SEWAGE DISPOSAL TESTING

MARYLAND STATE DEPARTMENT OF HEALTH

RE: Parcel B Conway Property
13452 Forsythe Road
Sykesville, Maryland

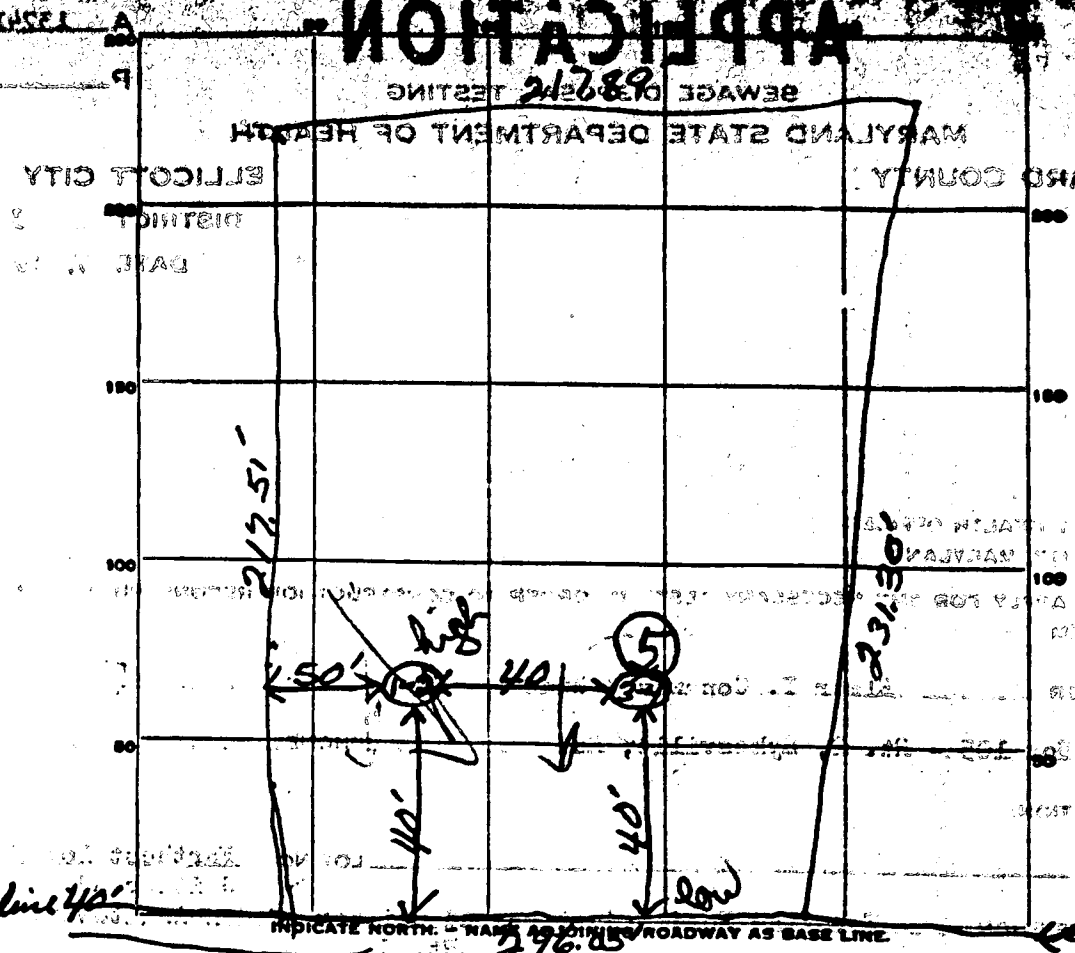
DATE	TEST NO.	DEPTH	PRE-WET		TEST - 1" DROP		TIME	
			START	STOP	START	STOP		
2/17/68	1	5'	12:33	12:35	12:35	12:38	3	
	2	10'	12:52	12:55	12:55	12:59	4	
	3	4 1/2'	1:02	1:11	1:11	1:14	3	
	4	10'	1:32	1:34	1:34	1:45	9	
(5/11/79)	5	14	DRY ALL SAND

5 1/2" trial hole R/H

James P. Buech
 13452 FORSYTHE RD.
 Sykesville, Md.
 21784
 410-442-1453
 Scale 1" = 30'

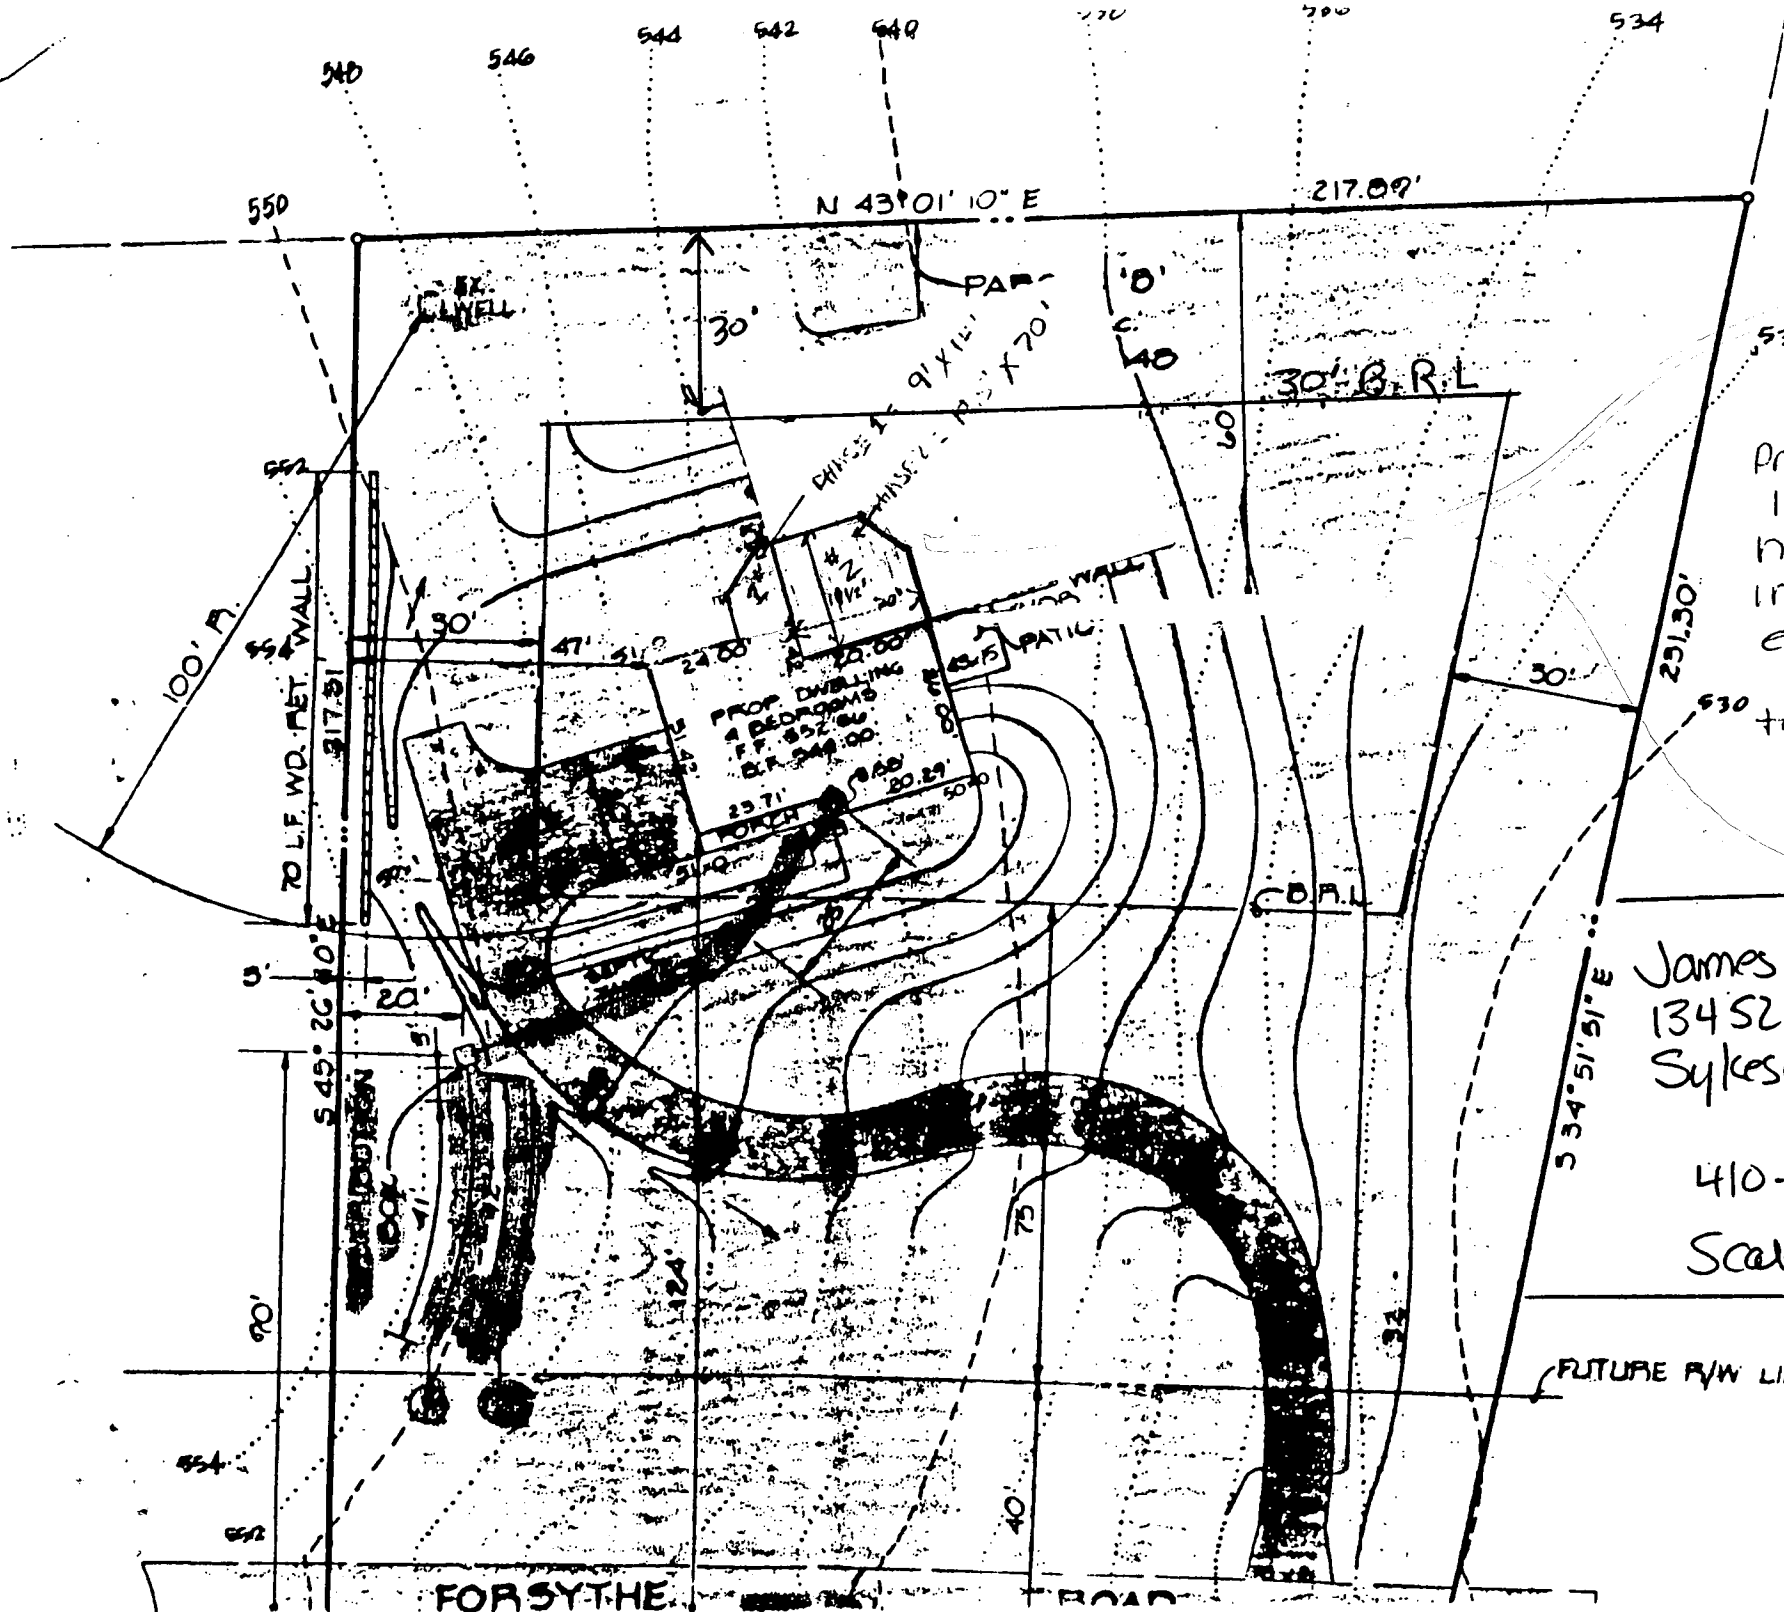
8/7/96
 Proposed deck location will have no impact to existing well or septic or to proceed
 ALL
 8/1/96
